NEURO CLINIC OF COLORADO LLC

1400 SOUTH POTOMAC STREET

City of Aurora Building Division
Project: *NEURO CLINIC OF COLORADO*
Address: *1400 S. POTOMAC ST. #220*
Occupancy Group: *B*
Construction Type: *II-N-SPK*
RSN: *731035*
Permit: *13-676049*

City of Aurora Building Division
Reviewed for Code Compliance
Approved as Noted: *J Eckert*
Date: *Jul 24, 2013*
2009 INTERNATIONAL CODES & 2011 NEC

1 PROXIMITY PLAN
LEVEL TWO NO SCALE

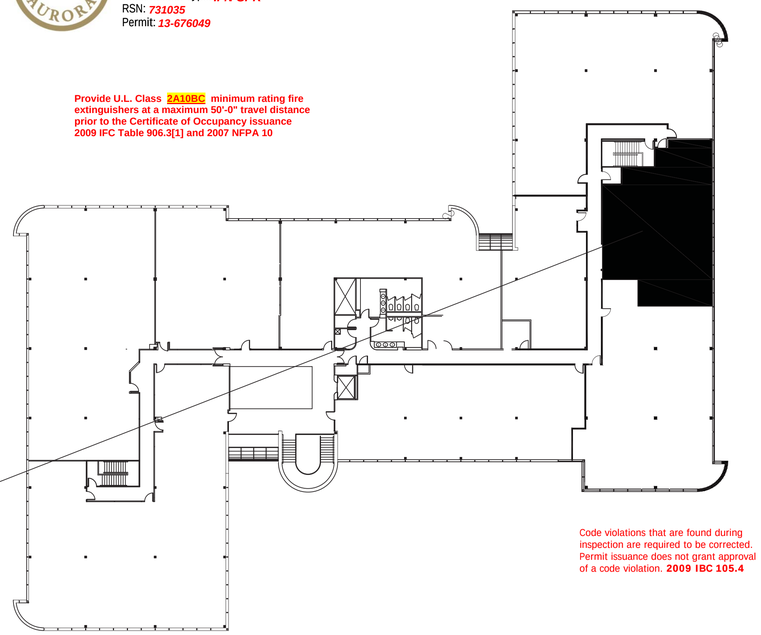
Provide U.L. Class 2A10BC minimum rating fire extinguishers at a maximum 50'-0" travel distance prior to the Certificate of Occupancy issuance 2009 IFC Table 906.3[1] and 2007 NFPA 10

Code violations that are found during inspection are required to be corrected. Permit issuance does not grant approval of a code violation. **2009 IBC 105.4**

1 MECHANICAL PLAN
SCALE 1/8"=1'-0"

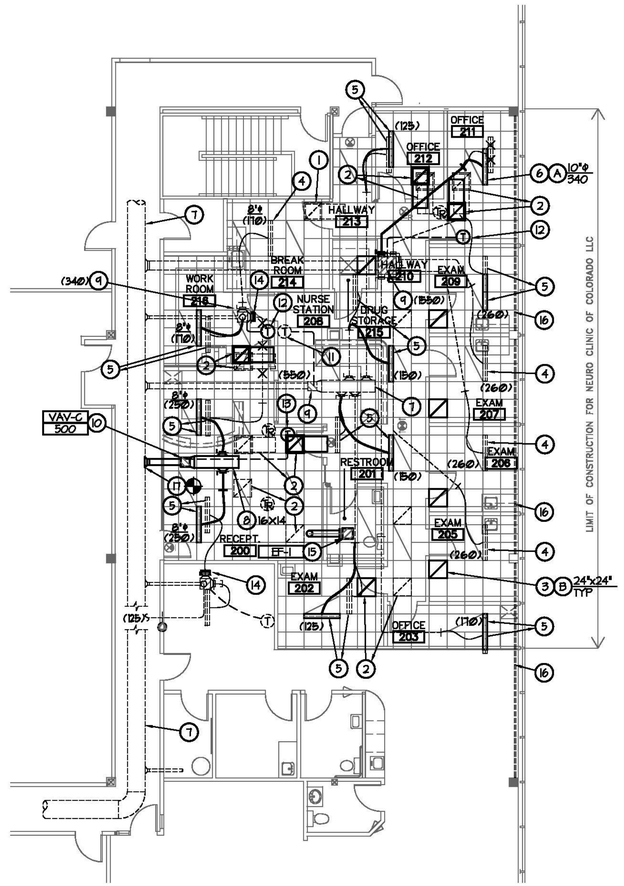
Provide proof of a flame spread <26 and smoke development <51 for any materials used within a plenum.
2009 IMC 602.2.1

1 WASTE AND VENT ISOMETRIC
SCALE: NONE

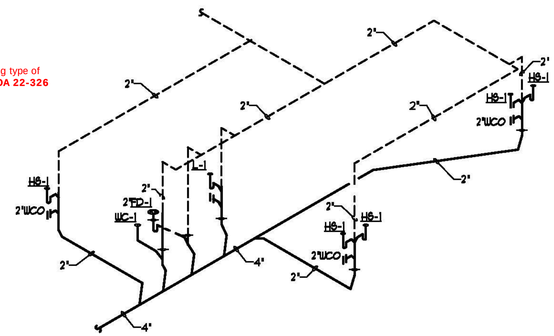
Provide self closing or metering type of faucets in restrooms **2009 COA 22-326**

2 POWER PLAN
SCALE: 1/4" = 1'-0"

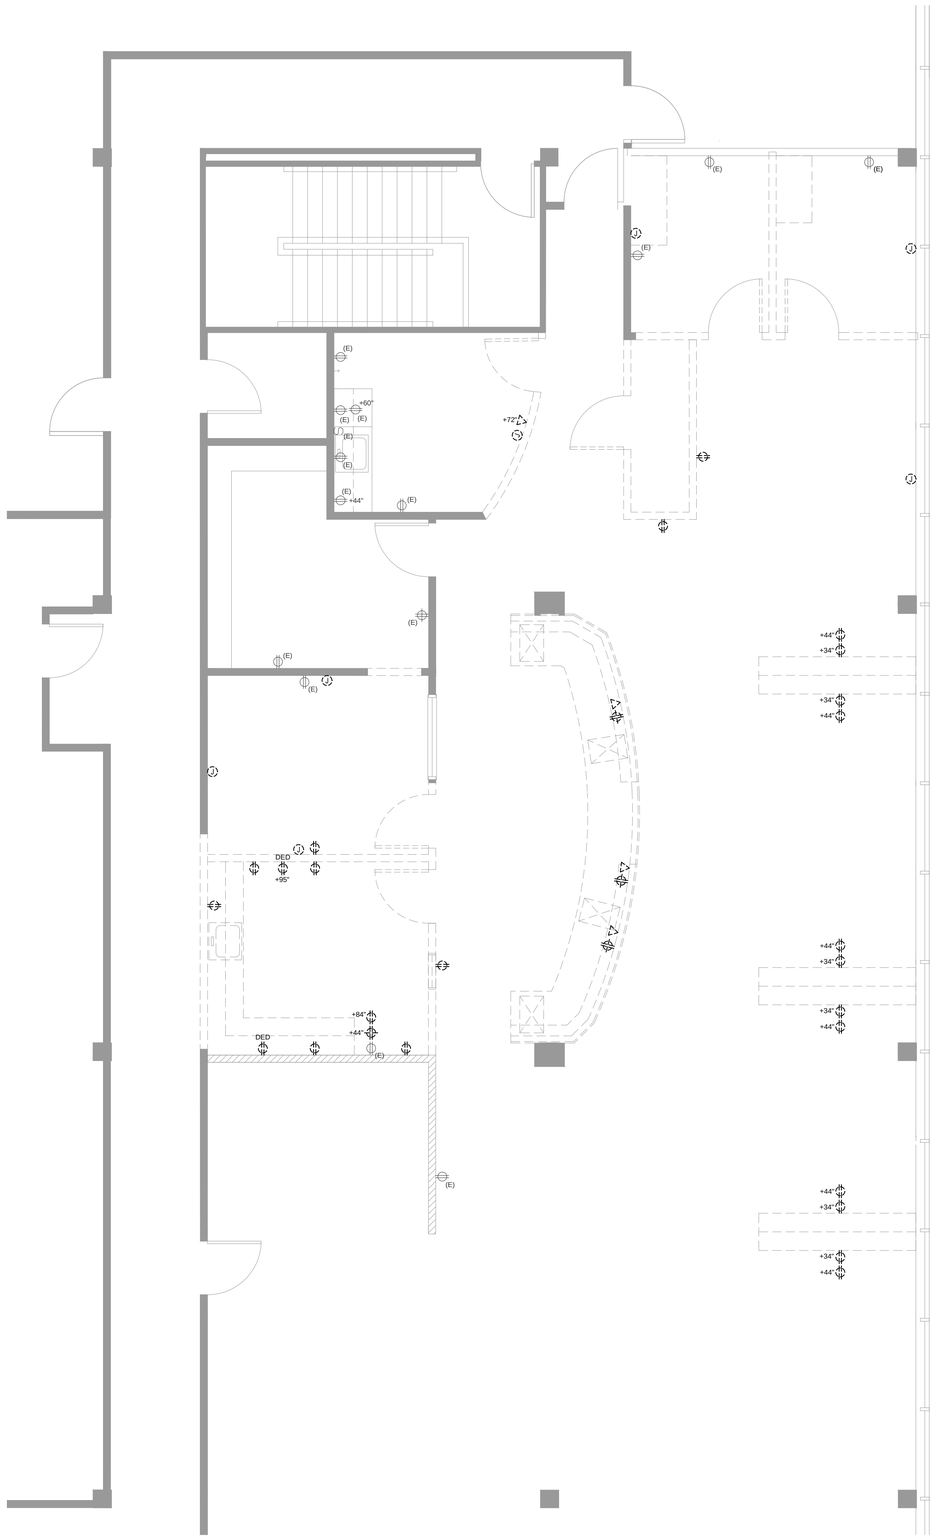
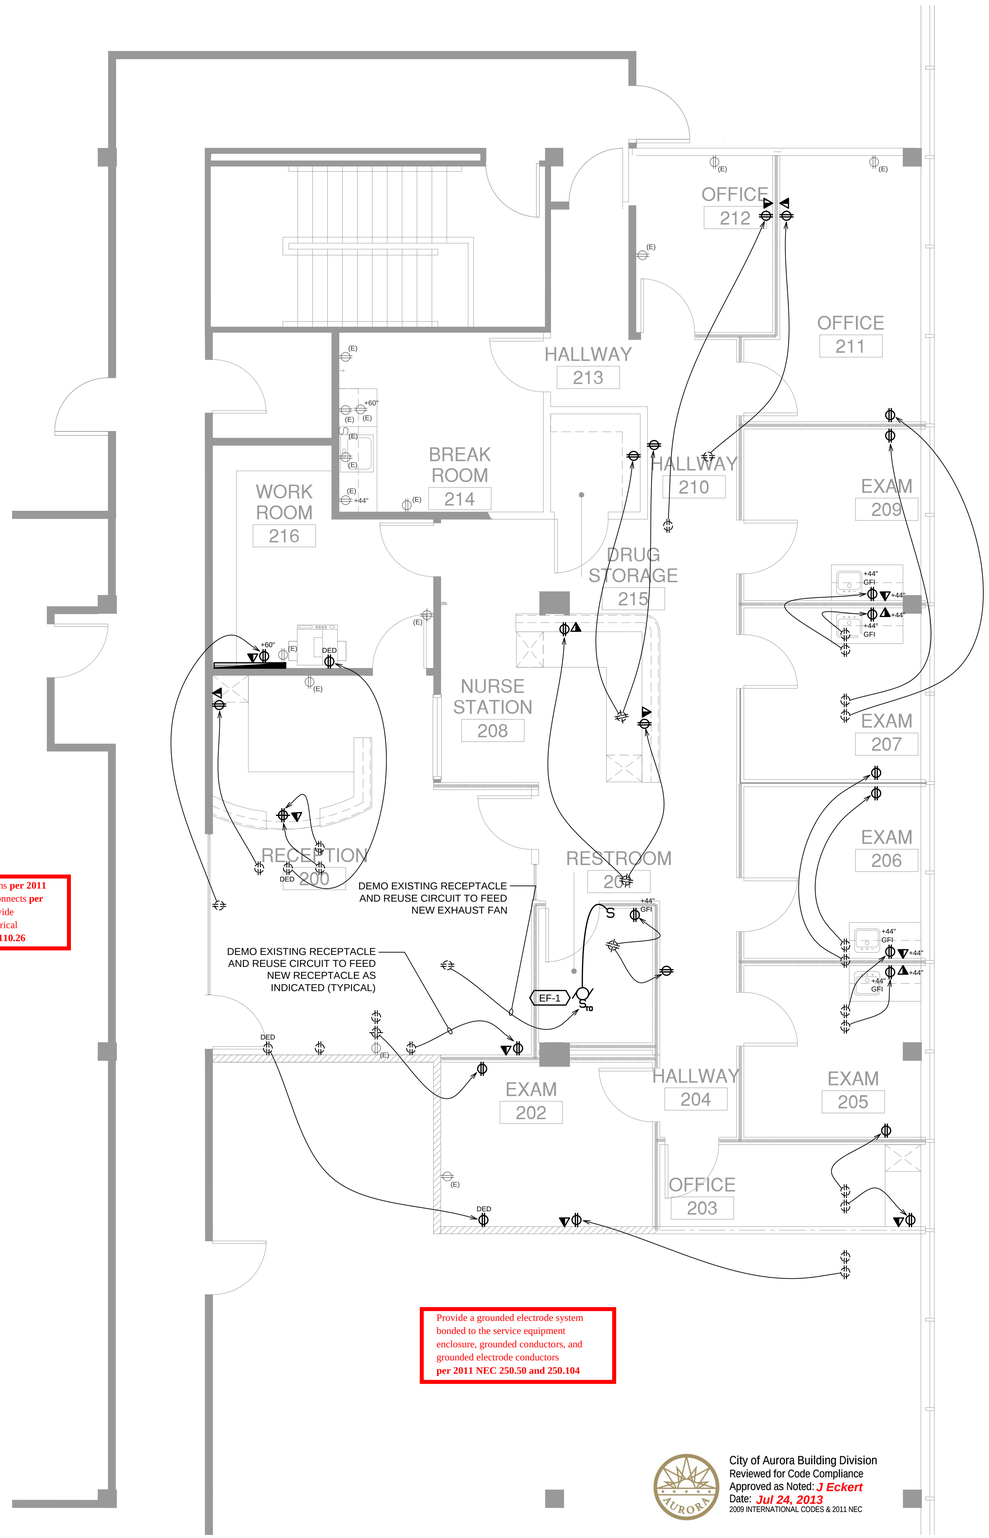
Install electrical connections **per 2011 NEC 110.14,** identify disconnects **per 2011 NEC 110.22** and provide working space around electrical equipment **per 2011 NEC 110.26**

Provide a grounded electrode system bonded to the service equipment enclosure, grounded conductors, and grounded electrode conductors **per 2011 NEC 250.50 and 250.104**
